URGENT FIELD SAFETY NOTICE

GEHC Ref# 32047

RE: Infant Warmer System (IWS) Hot “Heater Head” Screw could Fall onto the Bed

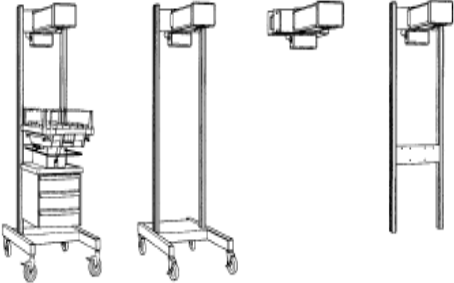
Hot screws from the “Heater Head” of the IWS could fall onto the bed if the “Heater Head” assembly has been improperly serviced. This situation can be clinically hazardous because thermal injury to a patient could result. Two injuries have been reported as a result of this issue.

As a result, if “Heater Head” service has been performed in the past, check to ensure that the screws are tightened as soon as the unit becomes available.

If the “Heater Head” assembly has not been serviced, check to ensure that the screws are tightened as part of your next regularly scheduled annual Preventive Maintenance check.

The attached Service Manual Addendum provides instructions for checking and tightening the screws. During each annual Preventive Maintenance check, continue to ensure that the screws are tight.
